JOINT REGIONAL PLANNING PANEL (Sydney East Region)

JRPP NUMBER:	2011SYE123
DA NUMBER:	LDA2011/0621
LOCAL GOVERNMENT AREA:	City of Ryde
PROPOSED DEVELOPMENT:	Construction of a five to nine storey mixed use development containing retail/commercial floor space at the Ground Floor level; 104 residential apartments; and parking for 170 motor vehicles over three basement levels.
STREET ADDRESS:	136-140 Victoria Road & 2-10 Wharf Road, Gladesville
APPLICANT:	Dragon Eye Properties Limited & Jade Developments Pty Ltd
NUMBER OF SUBMISSIONS:	58 objection letters and 419 letters of support.
RECOMMENDATION	Refusal
REPORT BY:	Architectus Group Pty Ltd, Consultant Town Planners to City of Ryde Council

Assessment Report and Recommendation

Figure 12 Proposed Key Sites built form plan

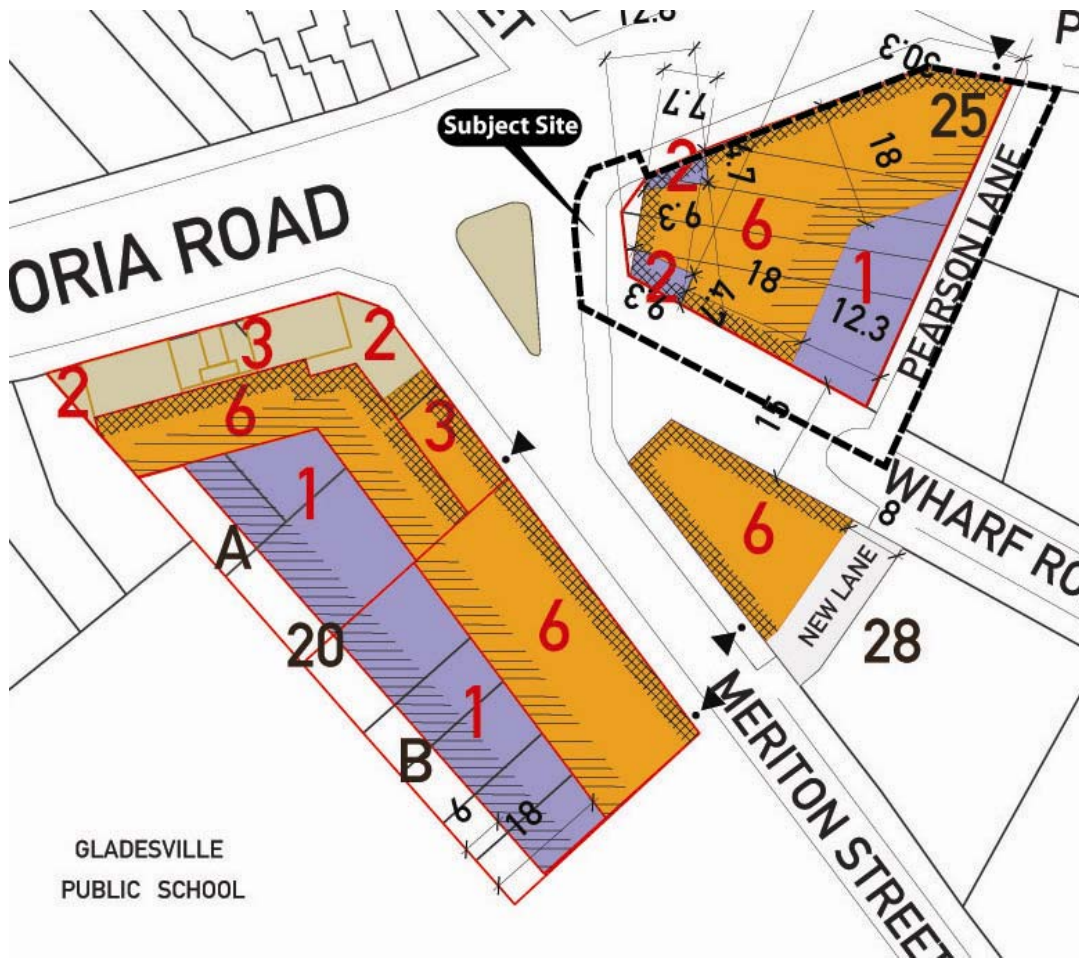
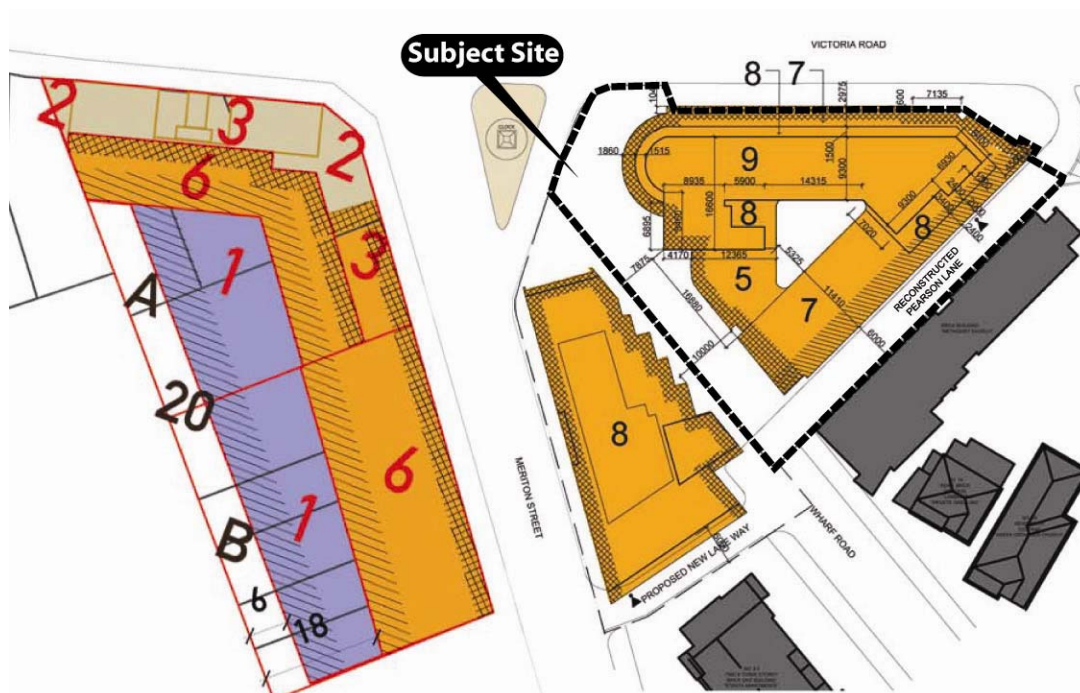
The proposed development is inconsistent with the Key Sites diagram for the subject site. The Applicant has submitted an alternative Key Sites diagram. The DCP (**Figure 11**) and proposed (**Figure 12**) Key Sites diagrams are illustrated below. In summary, the Applicant's proposed alternative Key Sites diagram increases building height to 5 to 9 storeys (plus

plant) including a 7 to 8 storey building component along the Pearson Lane frontage of the site. The alternative Key Sites diagram also varies the overall built form articulation in areas.

It is considered the proposal does not meet the criteria for variation of the adopted Key Sites Diagram, provided by Section 4 of Part 4.6 of Ryde LEP 2010, given the following:

Figure 13 Non-compliance with the maximum Key Sites diagram envelope

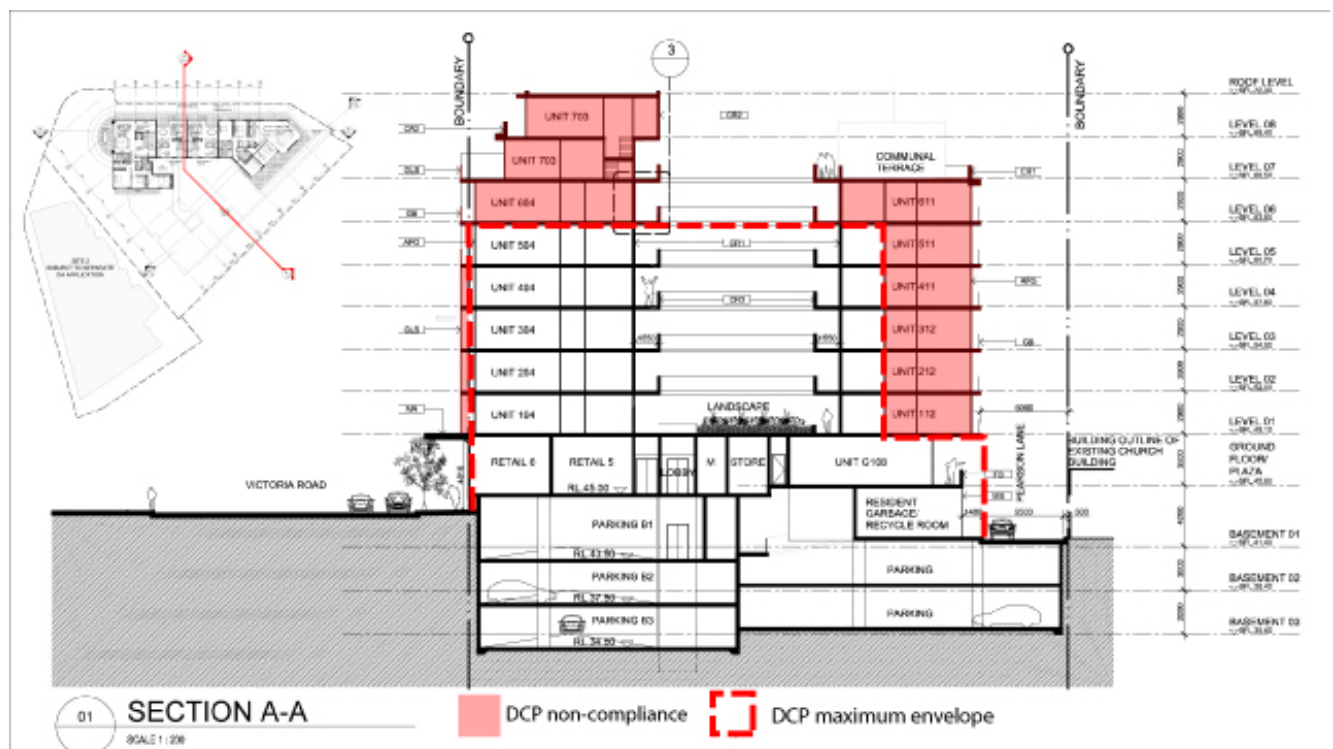
The maximum height under the adopted Key Sites diagram (or Built Form Plan) ranges from 1 storey at the rear to 6 storeys along the Victoria Road frontage. The building envelope required under the DCP provides for a transition from the Town Centre to lower density development to the south and south-east of the site. The non-compliance to the maximum building envelope prescribed under the Key Sites diagram is illustrated at **Figure 13**, **Figure 14**, and **Figure 15** below.

- The proposal does not respond to the site context, taking into consideration the density of residential development to the south and south-east and the envisaged surrounding development of 2-6 storeys under the Ryde DCP 2010. The DCP Key Site's diagram responds to lower building heights to the south and south-east of the site through stepping down the height from 6 to 1 storeys. The proposed Key Site Built Form Plan does not reflect this height transition.
- As stated above, there is no significant or additional community benefit provided for which justifies the significant increase in height and density.
- The planning controls provide for development on this site with greater height and density compared to the majority of other sites within the Gladesville Town Centre. A purpose of this was to support delivery of public domain improvements.

- The controls within the Ryde DCP 2010 are consistent with the Ryde LEP 2010 provisions. They have been independently tested by Architectus, which confirmed that the FSR of 3.5:1, as prescribed by the Ryde LEP 2010, can be achieved within the Key Sites built form plan under the Ryde DCP 2010. The Key Site diagram under DCP 2010 is therefore considered adequate in terms of achieving the height and density controls stipulated under the Ryde LEP 2010, and any public domain improvements Council has provided for through such controls.
